Seagate Technology

5/15/98

Subject: Revision 1 of the Proposal for the Fast 80 Specifications in the SPI-3 Standard

Attachment: Fast 80 Draft for SPI-3 Revision 1

Figure 4 - Fast-80 System setup and hold timings (all times in ns)

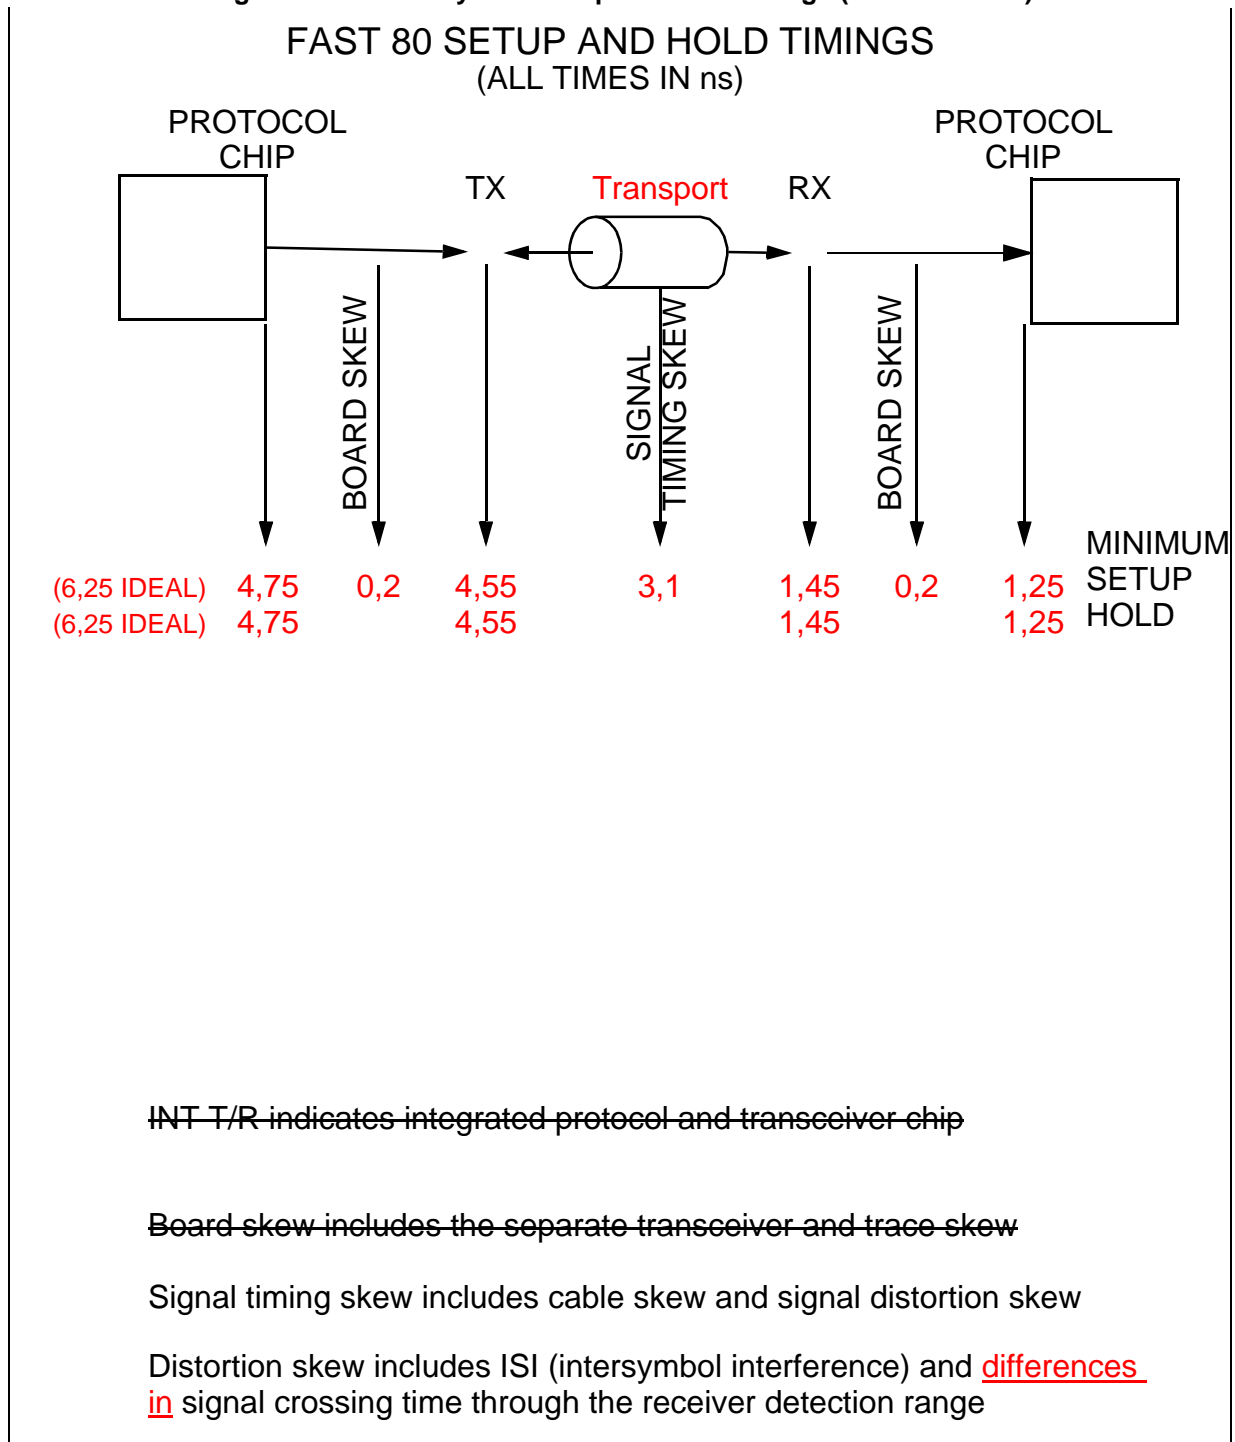
The principal changes in revision one are adjustment of the Fast 80 timing budget in Table 1 and Figure 4 and a reduction capacitance from 20 pF to 15 pf. Someone during the meeting indicated that the rise and fall time requirements were missing. At the time I was not able myself to quickly indicate where the requirement was but assured the person that I had not changed or purposely removed the requirement. In fact I have since determined that it is still safely in clause 3.4.
